# The Meadows to Castle Terrace Walk and Cycle Improvements Consultation Report

April 2018

This report summarises the consultation undertaken during the preliminary design stage of walking and cycling improvements to QuietRoute 6; The Meadows to Castle Terrace.

Figure 4 Lady Lawson Street at West Port proposals

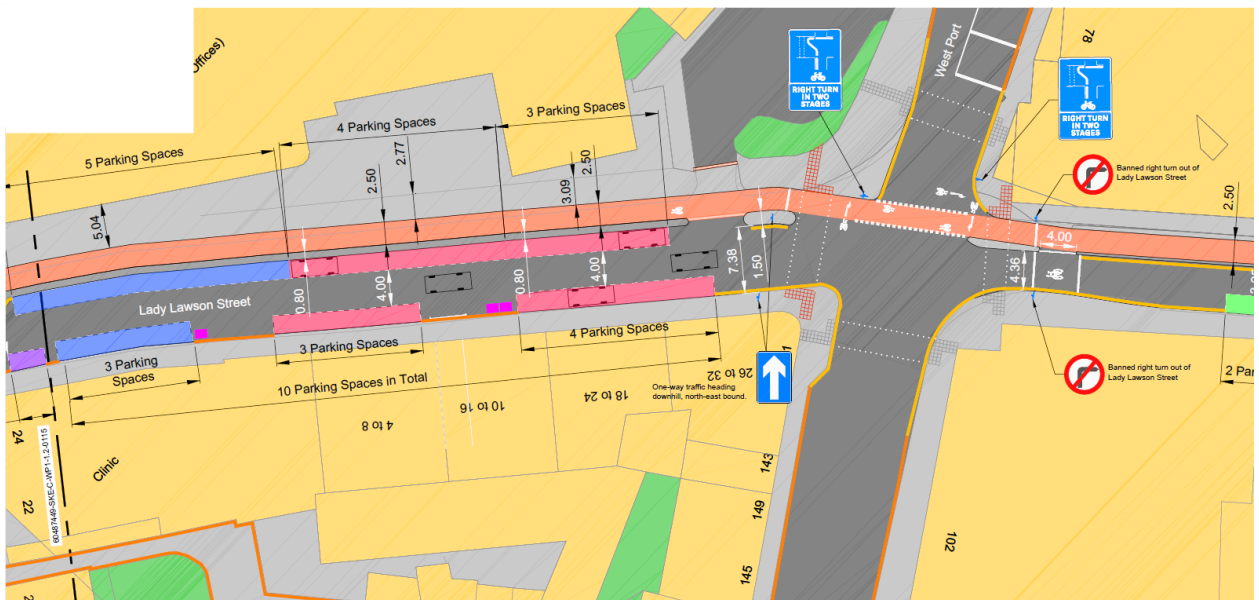
1. Proposed cycleway is too narrow (3)
2. Lack of clarity regarding right-turn for cyclists (2)
3. Proposal fails to address issues with larger vehicles (e.g. coaches) causing congestion for other road users (1)
4. General improvements required around Lady Lawson Street (1)

- No turning right when at the junction of Lady Lawson Street and West Port. In reviewing this and taking into account traffic congestion, pollution and bicyclist/pedestrian safety - the group still feels that this needs to be relooked at as the West Port/Bread Street is at full capacity a lot of the time with traffic without addition of further lorries/buses/cars not being able to turn right to the Grassmarket. Adding to both air and noise pollution from the added weight of these vehicles. Having to make an extra journey 'around the block' so to speak. We appreciate that there is consideration in regards to the flow of Cyclists and pedestrian safety and as mentioned maybe those cyclists coming down Lady Lawson Street to the junction will need to remain vehicular and those cyclist coming up the 'new' one way part of Lady Lawson Street may have to adhere to the pedestrian lighting system, much as they do in crossing Melville Drive.

- Based on a detailed topographical survey of the site, which will be done during detailed design, we shall reconsider whether it is necessary to change the northern section of Lady Lawson Street to one way. Initial site measurements suggest that there may be more street width than the OS base map indicates, this may permit retaining two-way traffic flow.

1. We will re-consider whether banning the right turn is the best solution or if having a cycle only phase at the junction is preferable. To help determine this we will do a comparison of increased vehicle waiting/queuing times, due to the additional cycle signal phase, versus queuing and waiting incurred by traffic taking alternative routes to reach Grassmarket.
2. Based on a detailed topographical survey of the site we shall reconsider whether it is necessary to change the road to one way. Initial site measurements suggest that there may be more street width than the OS base map indicates. If so this might permit two traffic to remain.  
We will also consider ways to improve and formalise the loading along the route so that it can take place without blocking the carriageway.

Figure 8 Castle Terrace proposals at Lothian Road

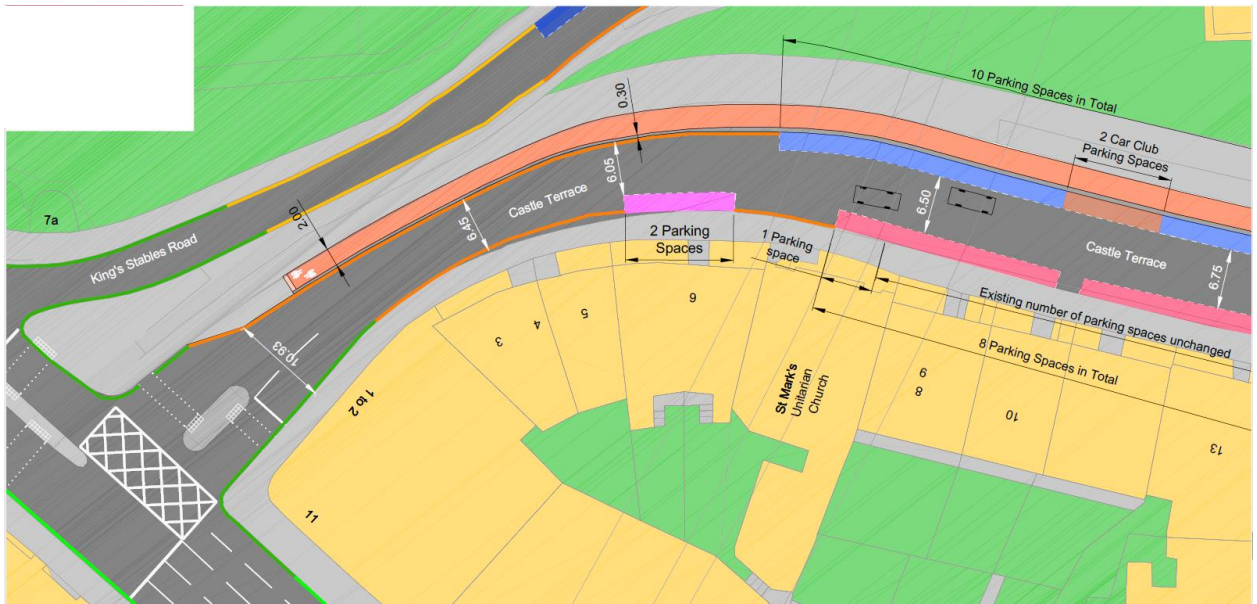
- planned footway widths on Castle Terrace as it nears Lothian Road do not seem to be shown on the plans, but the current north side footway of Castle Terrace at its narrowest point is less than 1.6m, with a 'clear walking zone' at the lamp post of less than 1.3m. The Council's Street Design Guidance stipulates an 'absolute minimum' of 2m and 1.5m respectively in such circumstances<sup>4</sup> – the opportunity should therefore be taken to achieve these footway minima on this stretch

*The footway widths are not shown as they do not change from the current widths. We shall be undertaking a de-cluttering exercise as part of the detailed design. At this stage we shall assess what practical steps can be taken to maximise footways within available budgets.*

Figure 9 Lothian Road crossing proposals

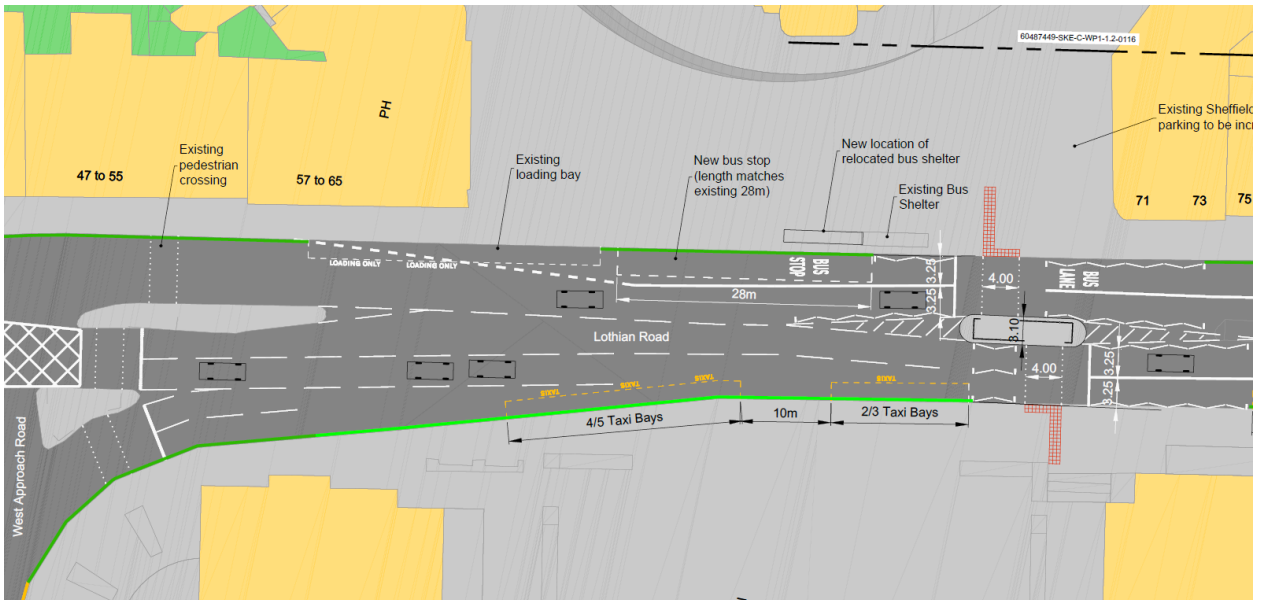
1. Lack of provision/integration with Lothian Road and beyond (10)
2. General improvements required at Lothian Road end of scheme (5)
3. Crossings of Lothian Road should be a single phase as opposed to two (4)
4. Focus of the scheme should be Lothian Road itself (1)

106	Support	I would much prefer the crossing of Lothian Road was single and not a two stage with an island in the middle.	This was considered, however due to the configuration of the signals it would require further re-configurations to the neighbouring junctions of that road. The cost and scale of this work is beyond the scope of this current scheme.
113	Support	The path around castle terrace roundabout seem counter intuitive for westward flow. The sharp bends also are not suited for two way cycle flow. It's necessary to separate flow and provide toucan crossing on the other two arms of the roundabout. No kerb or entrance/exit seems to be provided at junction with Lothian Road, cyclists seems to be left against traffic flow going westward.	The corner radii have been considered with regard to cycle flow but also slowing cyclists at interaction points with pedestrians and traffic thereby increasing safety. We do not consider separating flow is required and would increase costs. A dropped kerb entrance to shall be provided. We will reconsider how best to help cyclist re-integrate with traffic at the northern end of Castle Terrace.
